HISTORIC AND DESIGN REVIEW COMMISSION

HDRC CASE NO: 2019-463
ADDRESS: 111 BOSTON
LEGAL DESCRIPTION: NCB 578 BLK B LOT 8
ZONING: RM-4, H
CITY COUNCIL DIST.: 2
DISTRICT: Dignowity Hill Historic District
APPLICANT: LINDLEE LLC
OWNER: LINDLEE LLC
TYPE OF WORK: New construction, final approval
APPLICATION RECEIVED: March 10, 2021
60-DAY REVIEW: Not applicable due to City Council Emergency Orders
CASE MANAGER: Edward Hall

APPLICANT'S RESPONSE TO STAFF'S STIPULATIONS.

1 Site Plan
SCALE: 3/16" = 1'-0"

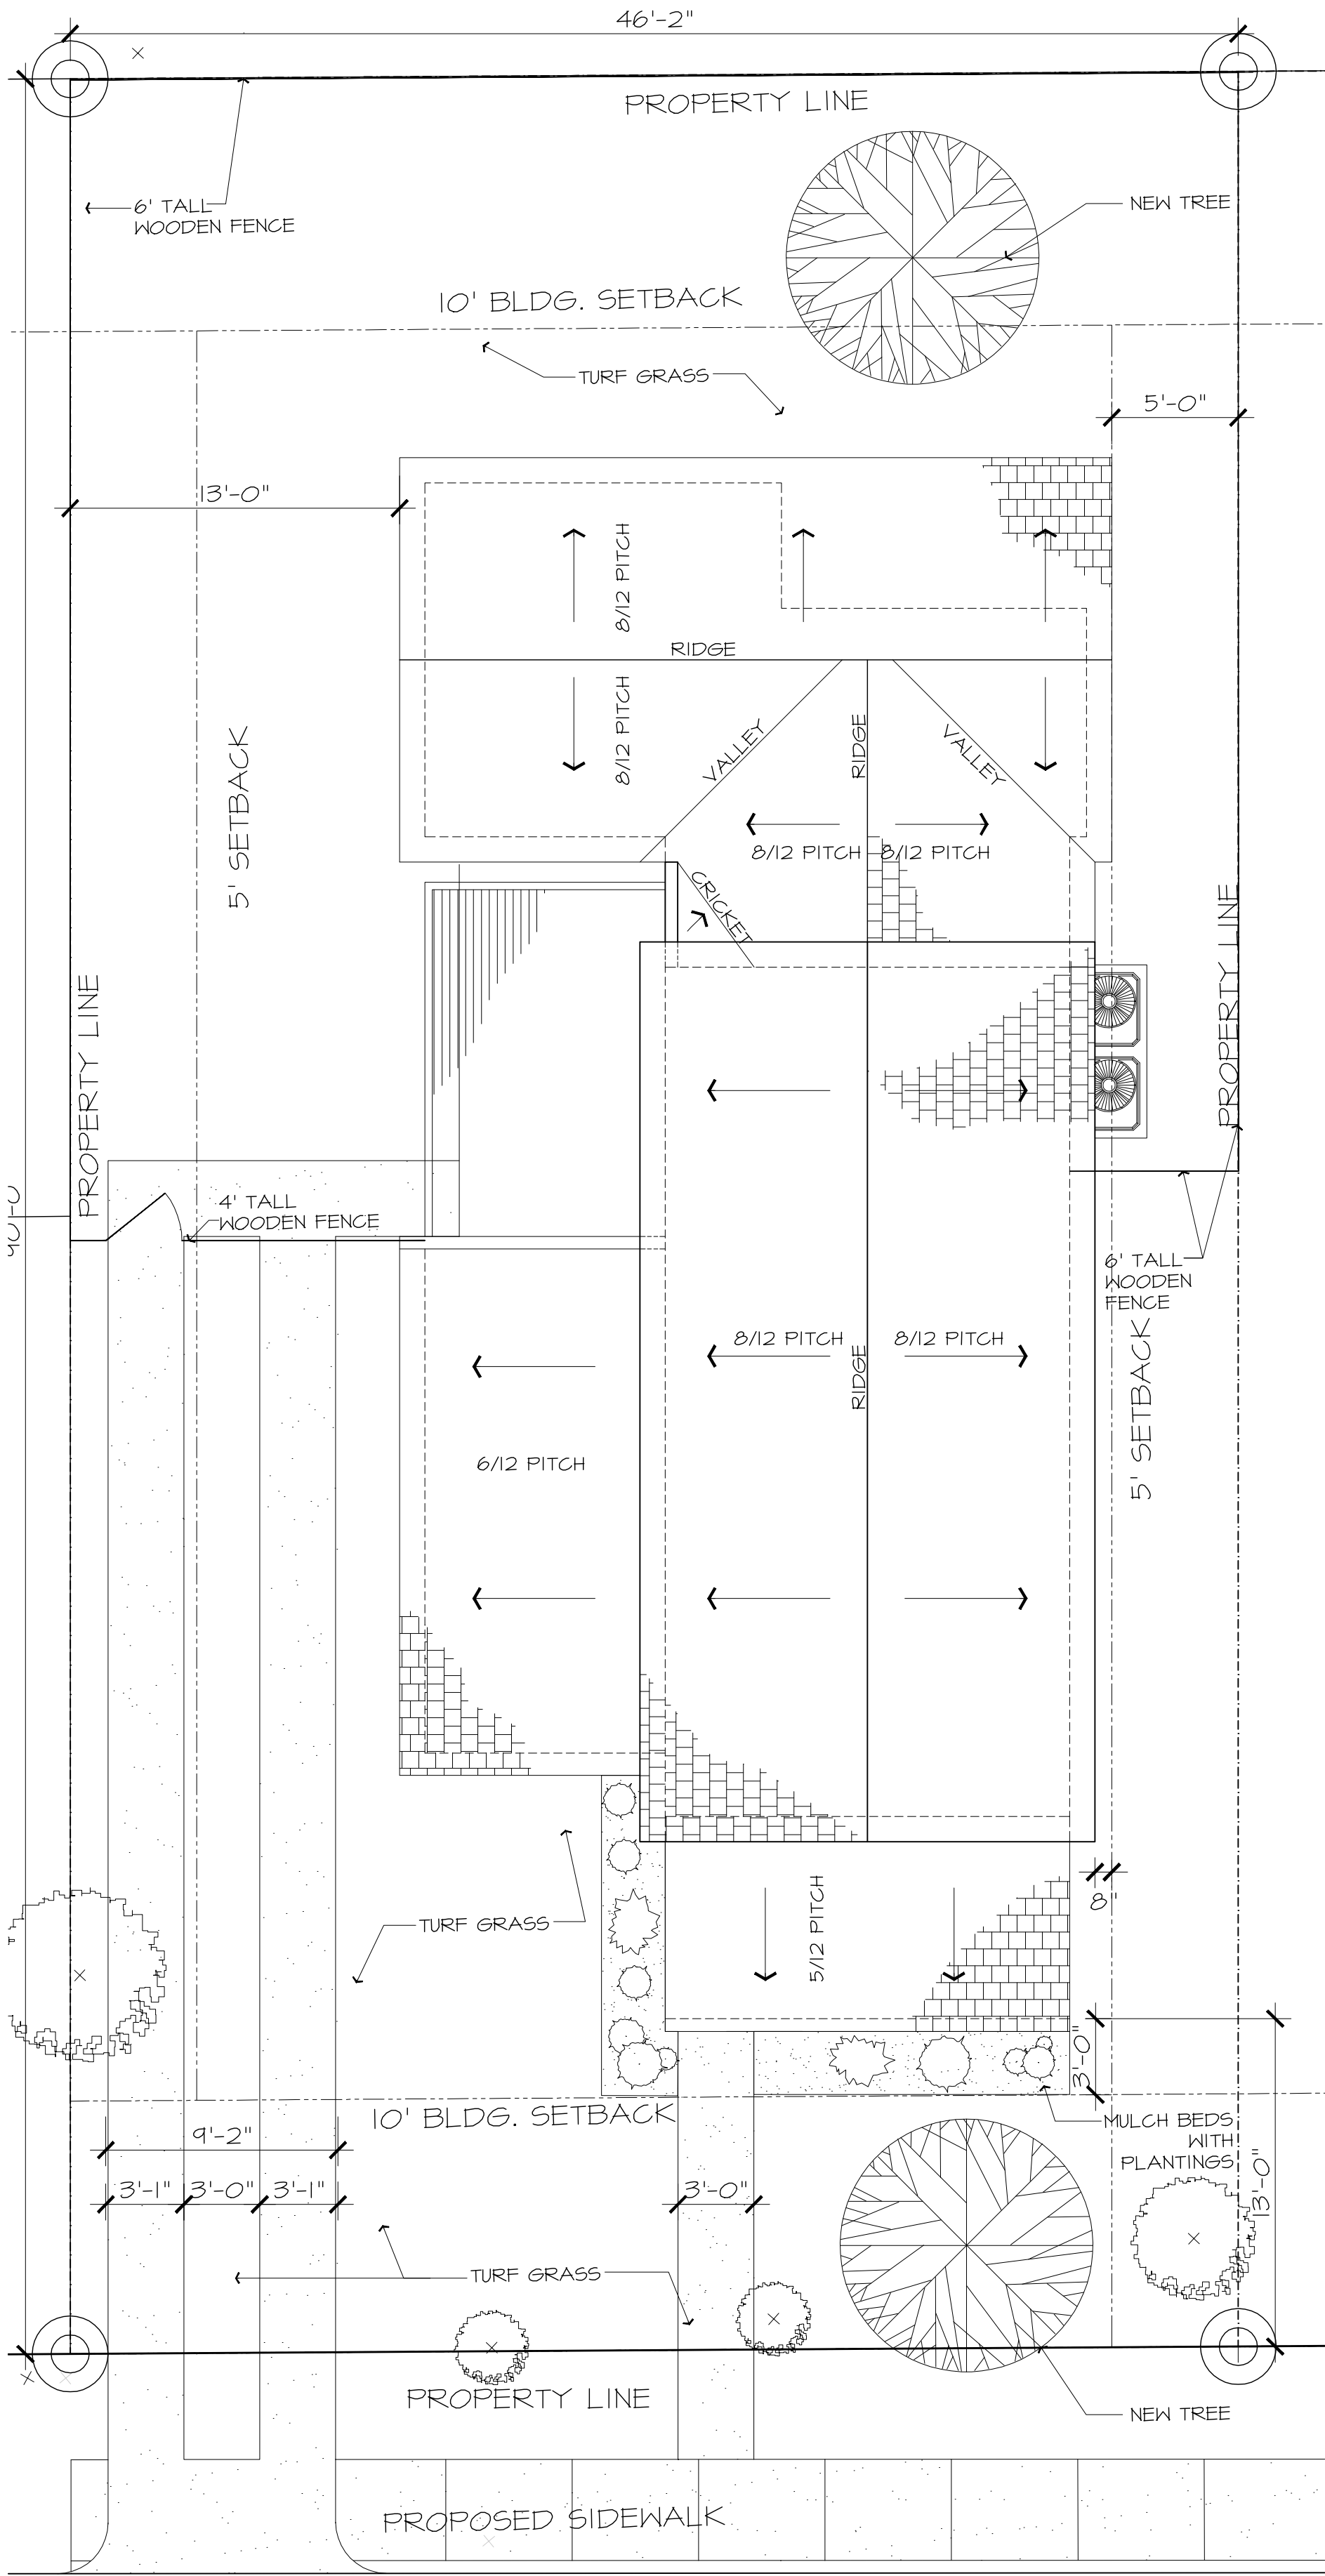
- i. That a setback diagram noting a setback that is greater than those of the adjacent historic structures be submitted, as noted in finding d.
- ii. That the applicant submit a street elevation noting all existing structures on the block (both east and west of the proposed new construction) to confirm the appropriateness of the proposed height and massing, as noted in finding f.

1. That a setback diagram noting a setback that is greater than those of the adjacent historic structures should be submitted. **The building sits back 3'-0" from the 10' setback (13'-0" from the property line). See attached site plan drawing A-1.1 and 111 Boston Setbacks.**

A-3.1
Exterior Elevations

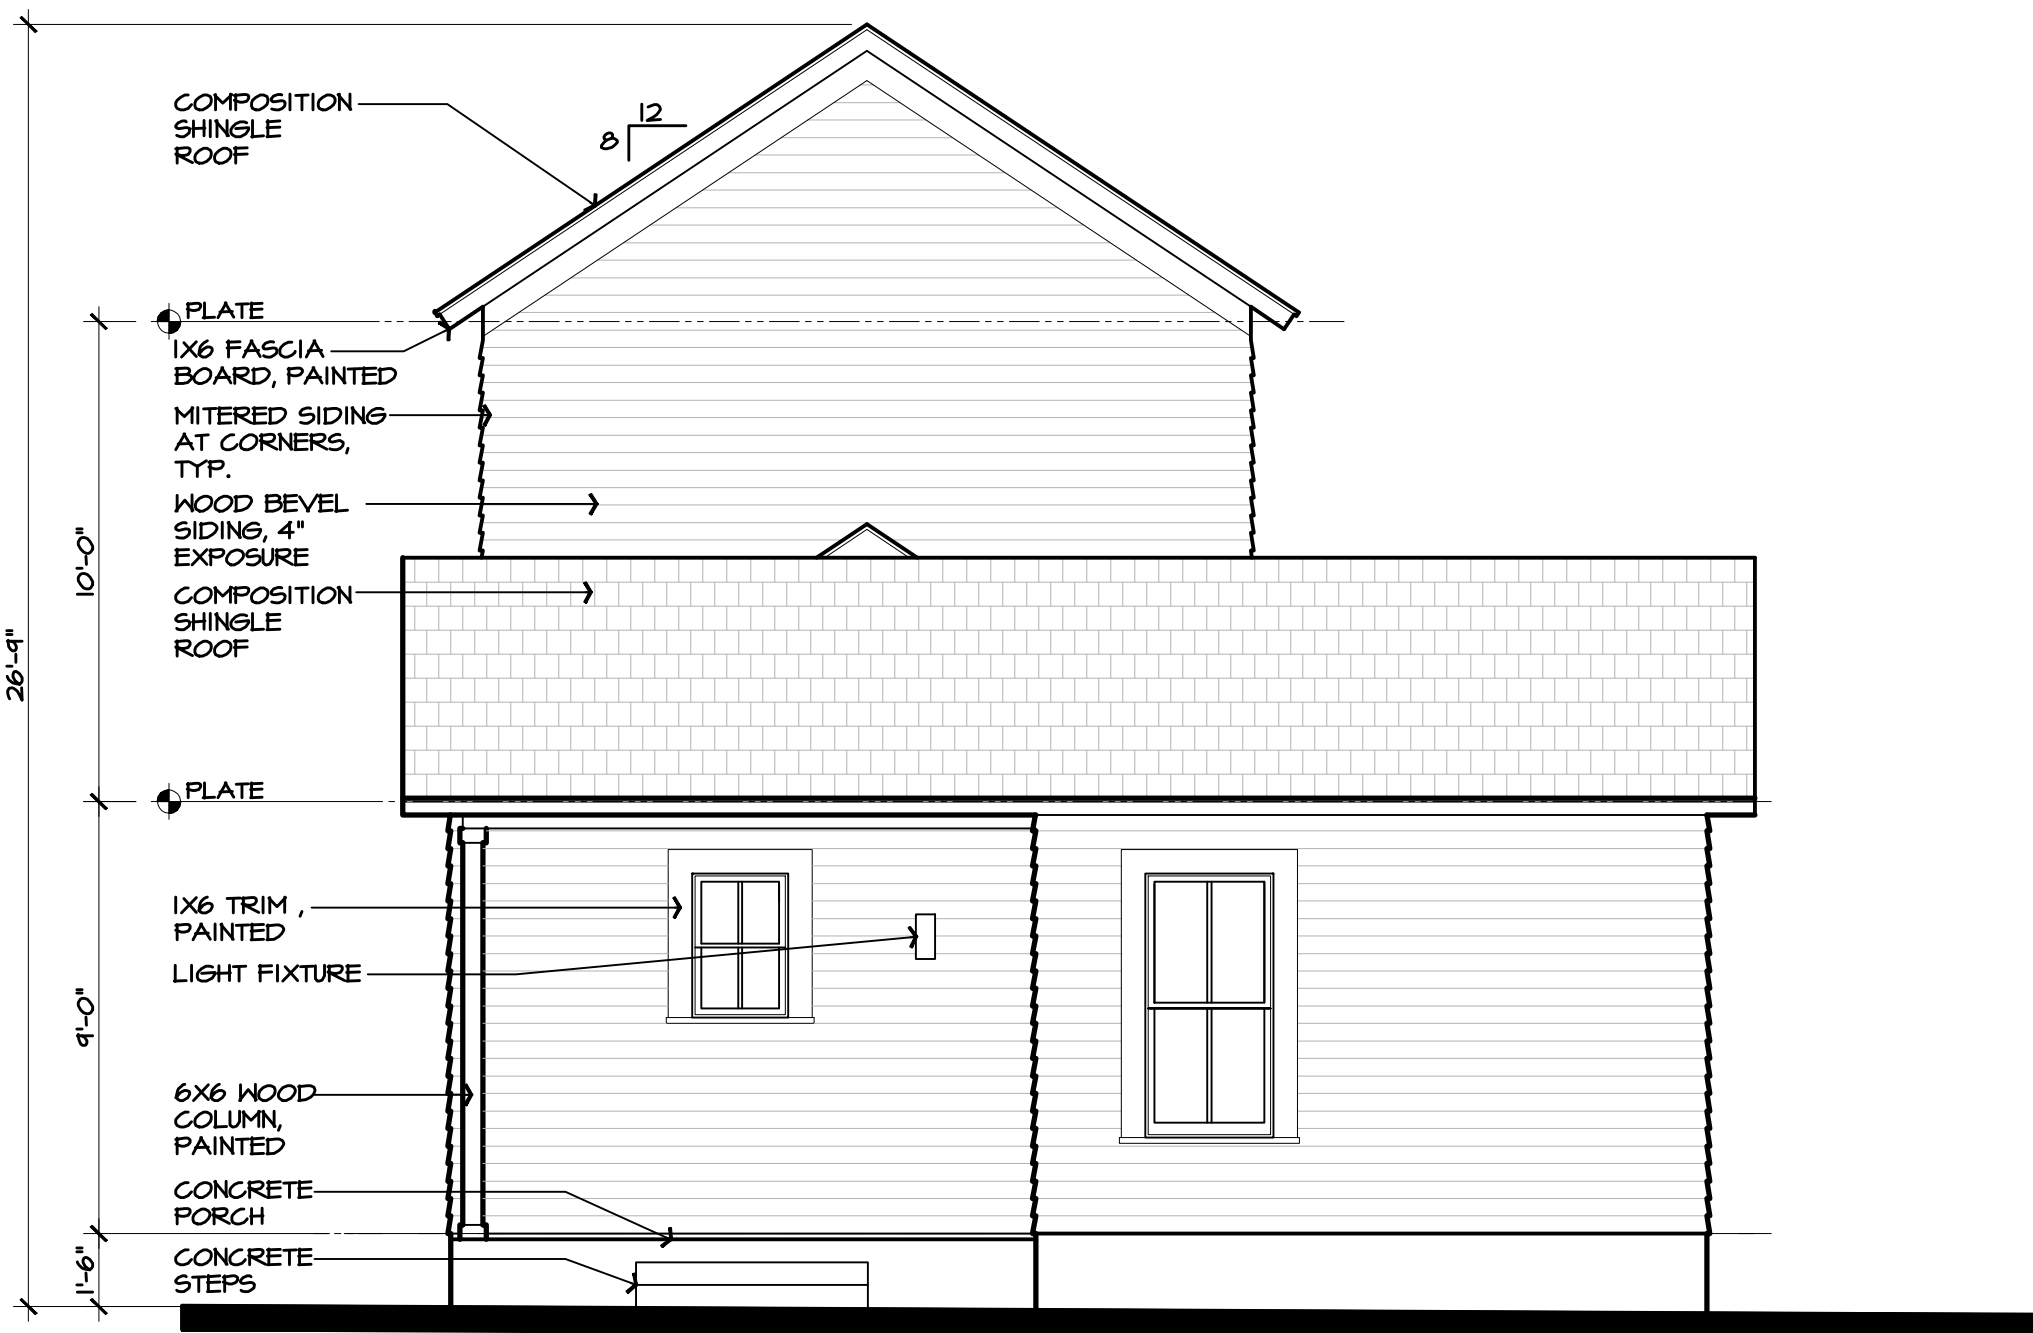
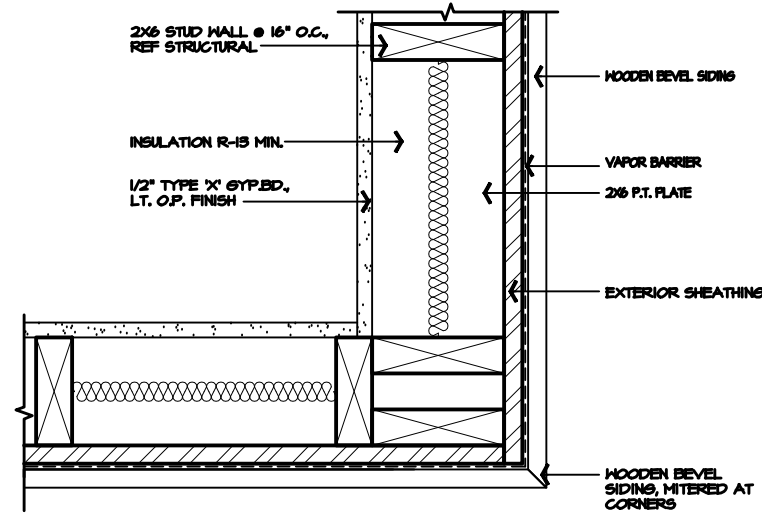
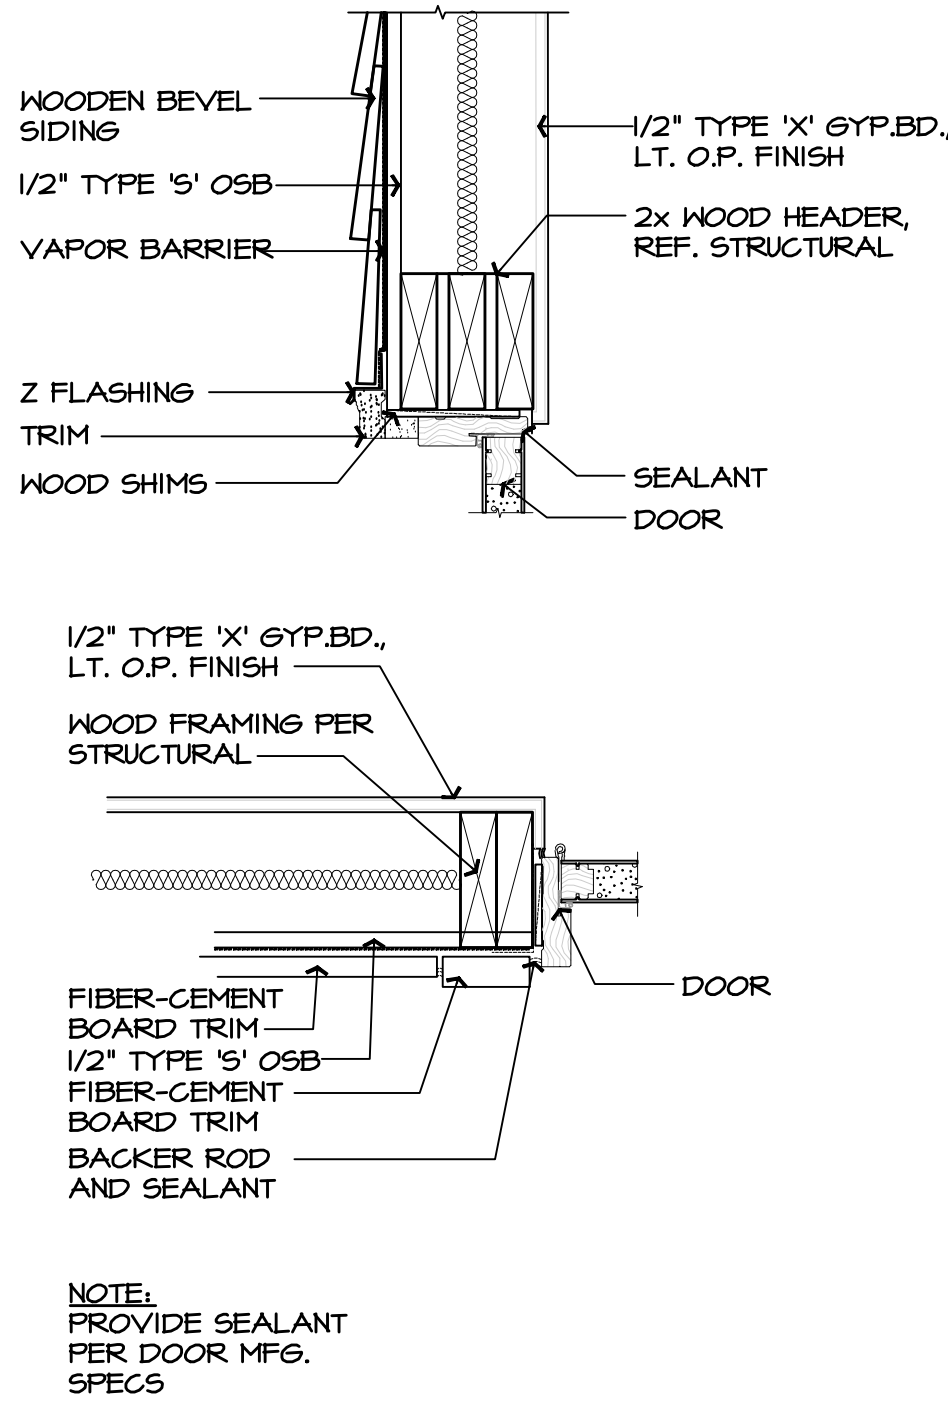
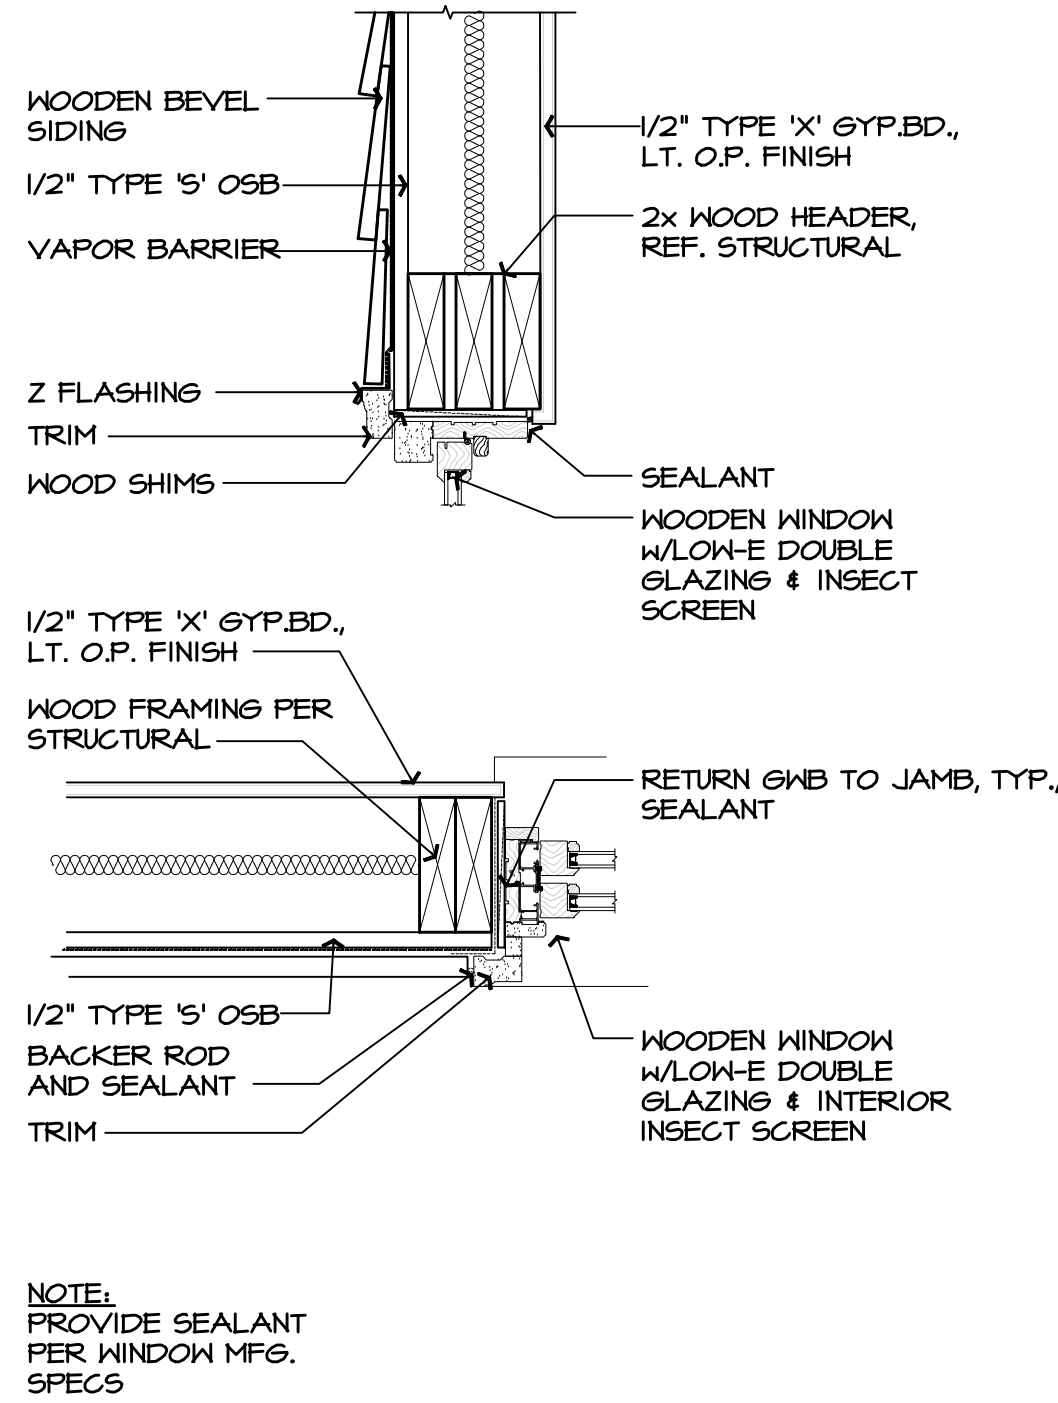
- iii. That the applicant reduce the proposed slope of the shed porch roof and incorporate the porch’s massing into that of the structure’s primary massing. This can be accomplished by extending the proposed porch roof’s width, or including a wrap around element that.

- iv. That larger, full sized windows should be incorporated in primary locations where smaller windows are currently located, specifically in locations on the front or near the front on side elevations.

3. That the applicant reduce the proposed slope of the shed porch roof to one that is comparable to shed porch roofs found historically within the district. **Slope was reduced from 5/12 to 4/12. Please see revised elevations, A-3.1.**

4. That larger, full sized windows should be incorporated in primary locations where smaller windows are currently located, specifically in locations on the front or near the front on side elevations. **The side elevation has been revised to incorporate larger windows. Please see revised elevations, A-3.1.**

1 WINDOW HEAD/JAMB/SILL DTLS
SCALE : 1-1/2" = 1'-0"

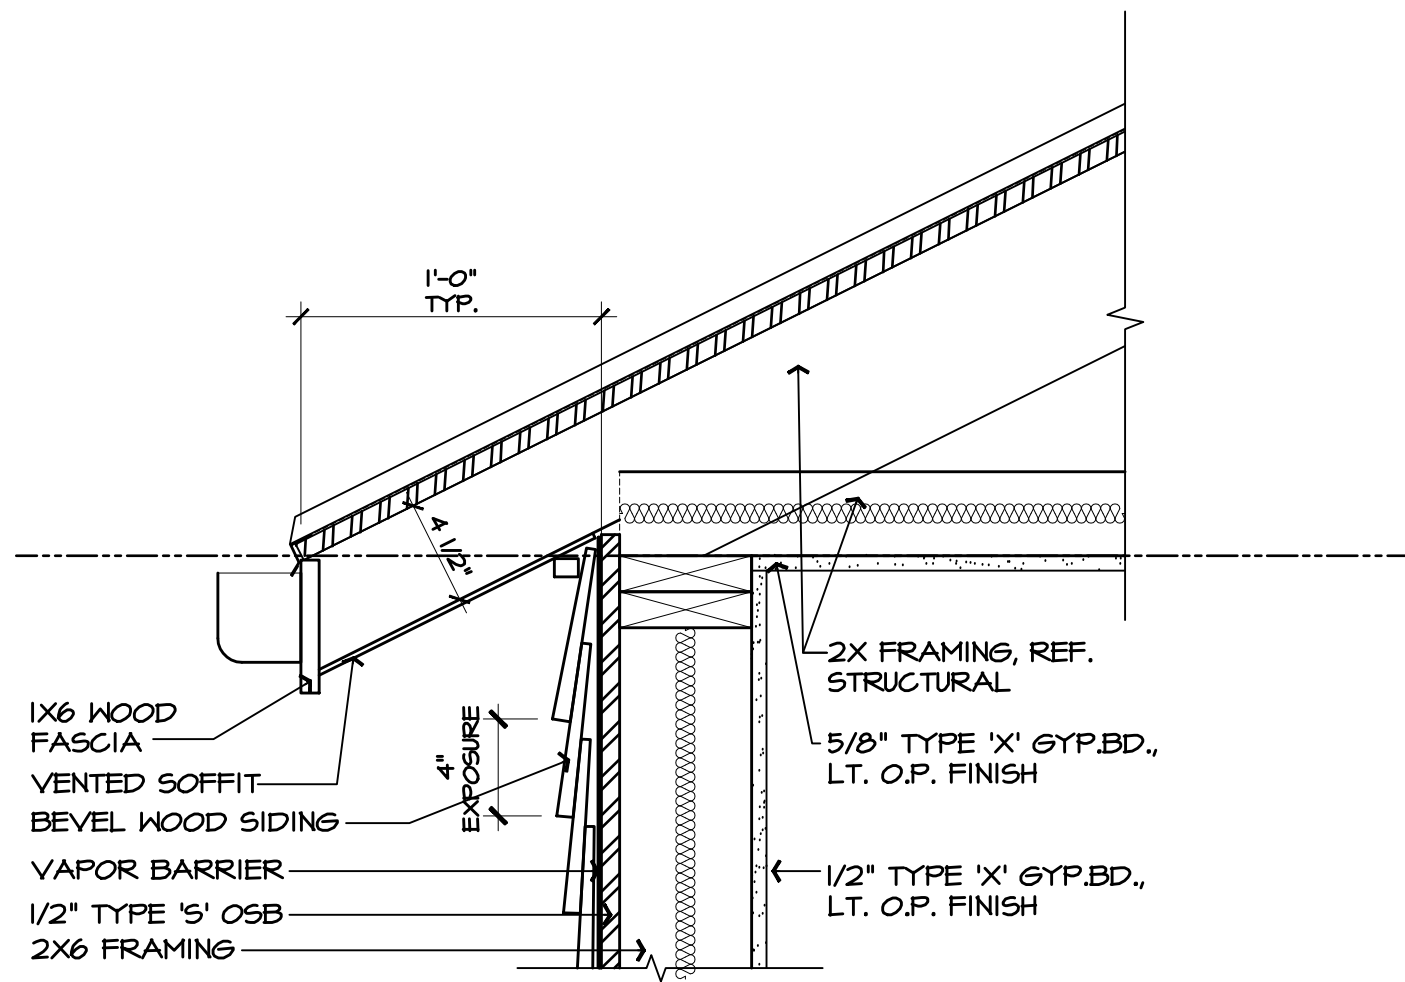
- v. That the applicant install wood or aluminum clad wood windows that are consistent with staff’s standards for specifications in new construction, as noted in finding n and in the applicable citations.

5. That the applicant install wood or aluminum clad wood windows that are consistent with staff's standards for specifications in new construction, as noted in finding n and in the applicable citations. **They will be traditional double hung, wood windows to meet the requirements.**
